# Agenda HISTORIC DISTRICT COMMISSION

Regular meeting 6:30 p.m. March 6, 2024 Board Meeting Room of Town Hall Annex, 105 E. Corbin St.

### ITEM #6. A:

### ITEM #7. A:

Conditions: Fence will follow the slope of the land (i.e., not stepped). Fence will be painted white

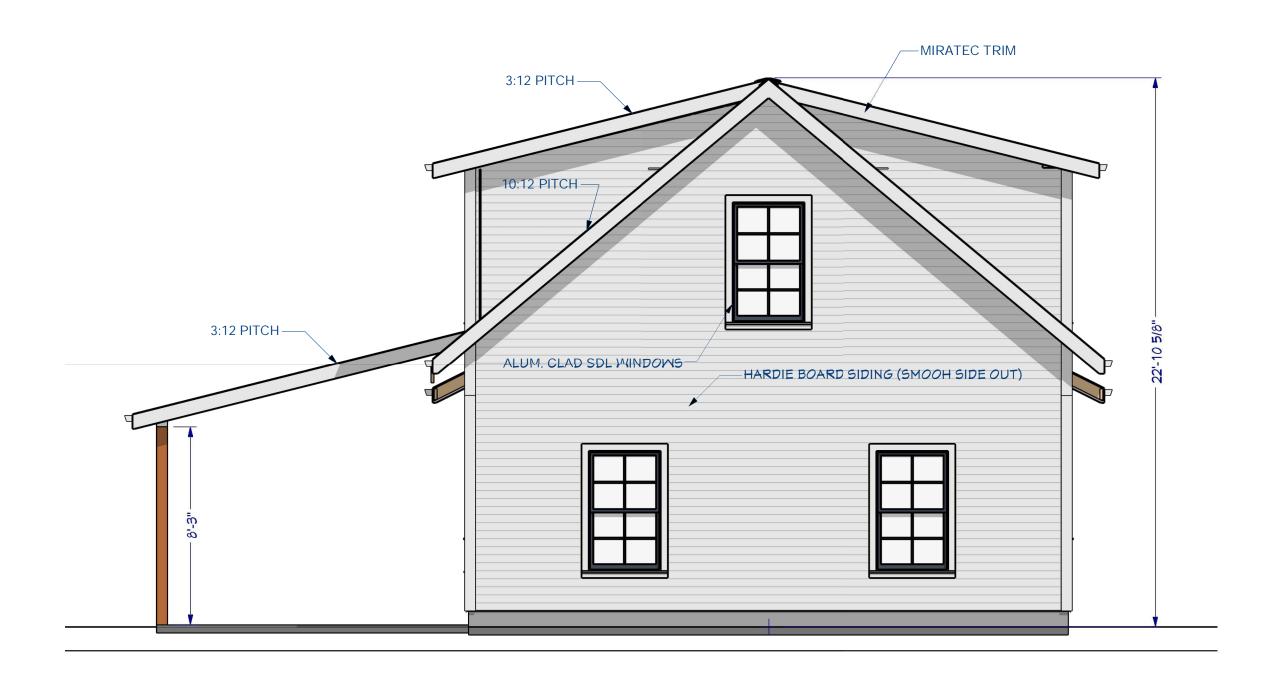
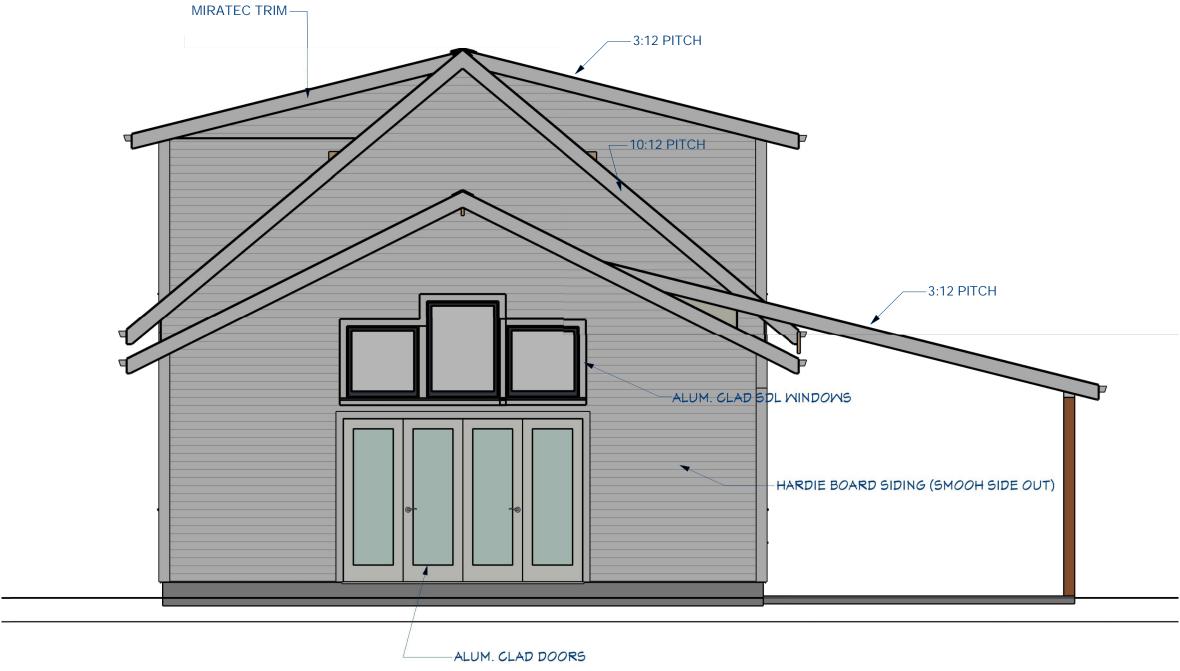
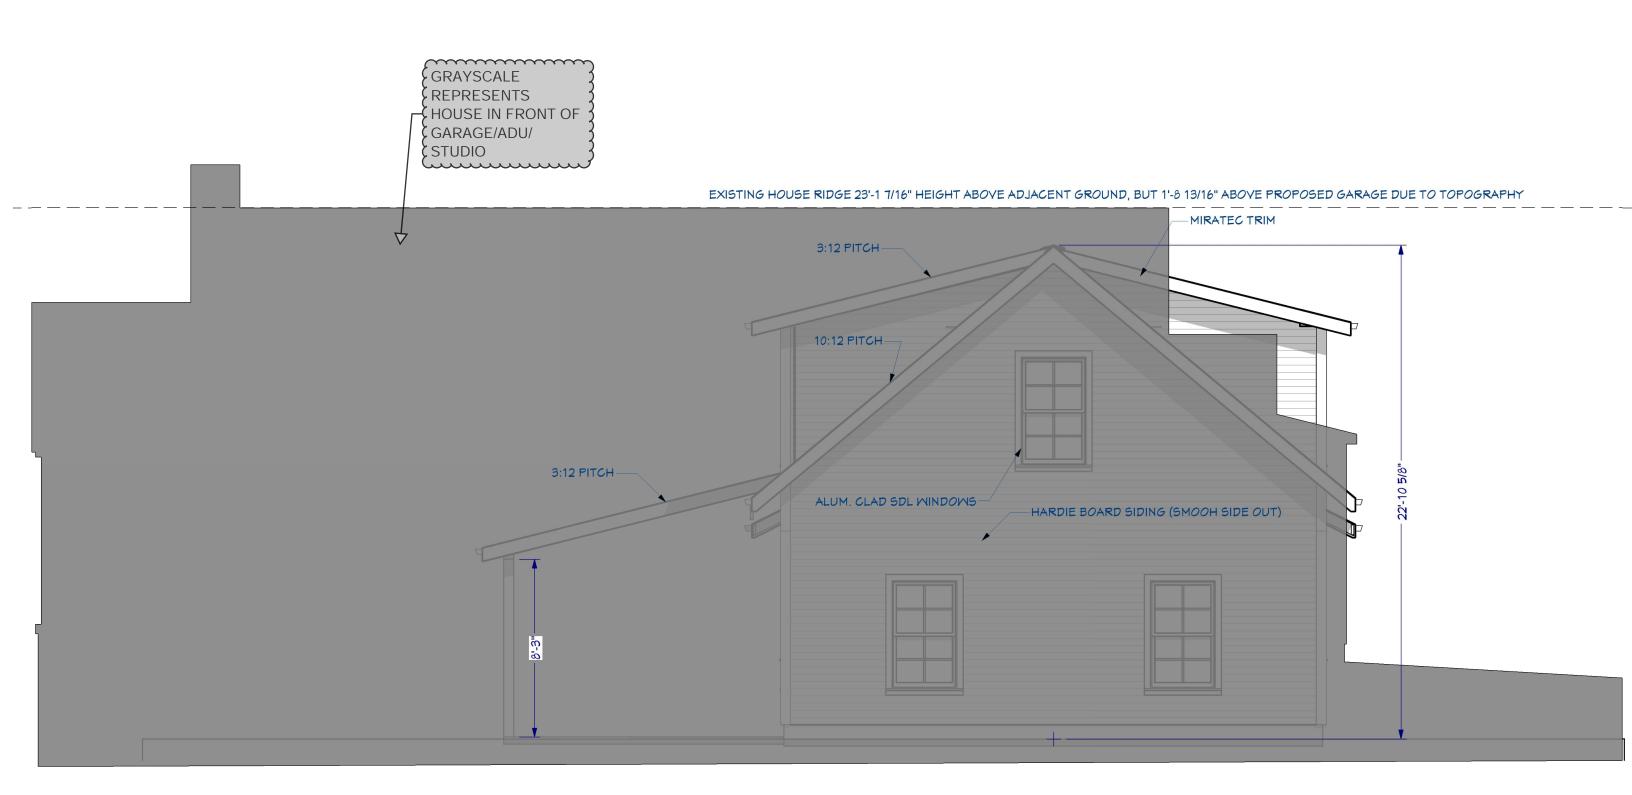
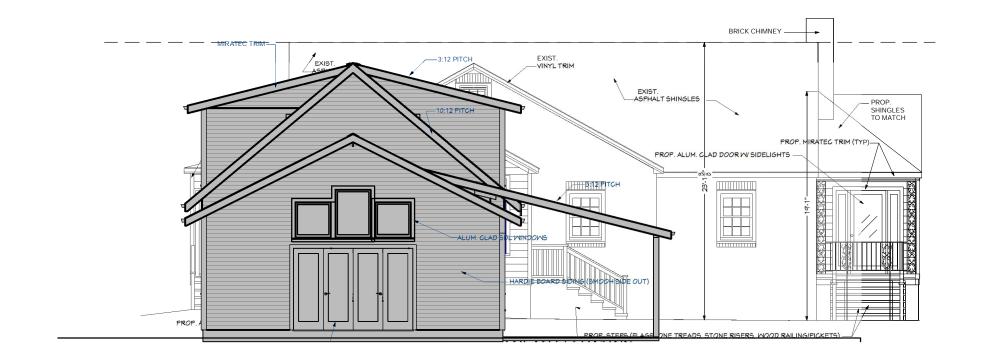
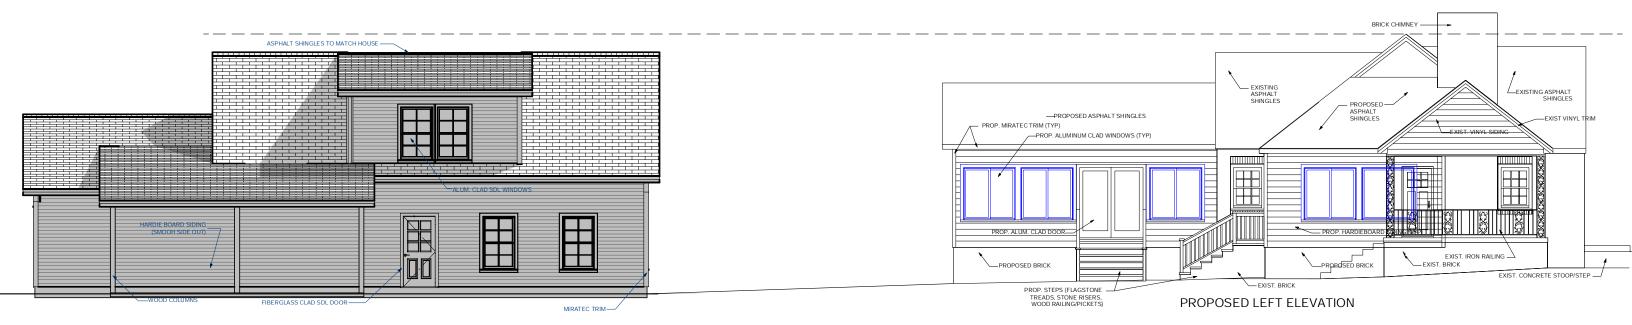
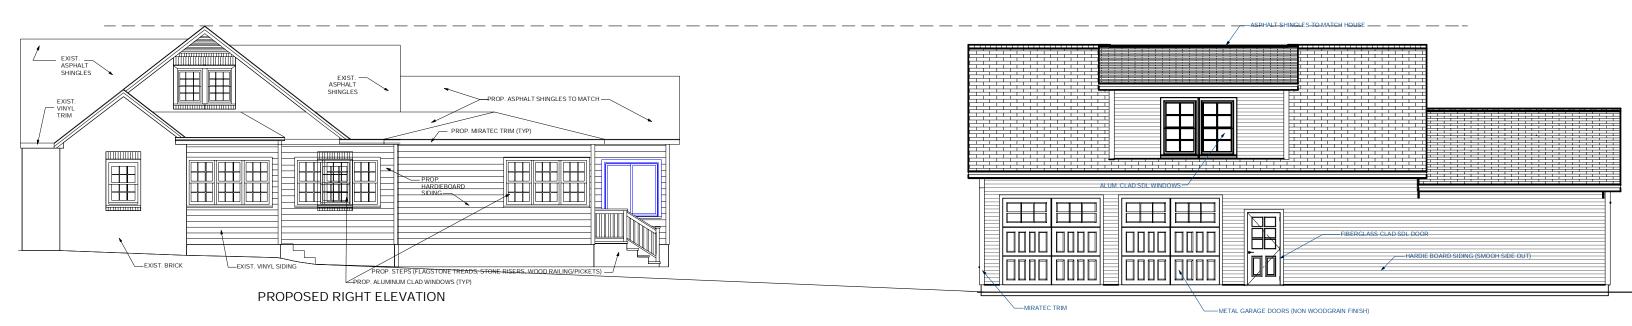
- Staff had questions about *New Construction of Outbuildings and Garages* 2 and 3 and *New Construction of Accessory Dwelling Units* 1, 5, 6, and 8. The applicant has provided several photo examples of garage/accessory structures within two blocks of the subject property.
